**PRODUCT CHANGE NOTICE**  
PCN Form (D4-E000-73)

**PCN#10-011**

Open core TC-series

List of models affected & sample view with lid

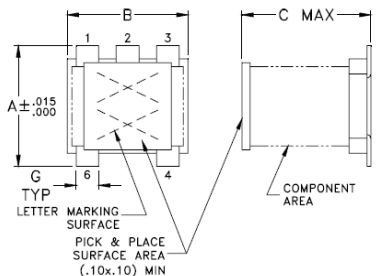
- Addition of Tophat™ (flat 'lid') to top-side of the core to enhance customer ability to handle in automated Pick and Place assembly
- Eliminate need to vary pick-up nozzle size in Pick and Place assembly
- Provide a surface for unique device marking using letter code (see attached)

- No change in fit or function
- Minor change in form (device appearance and ability to mark)
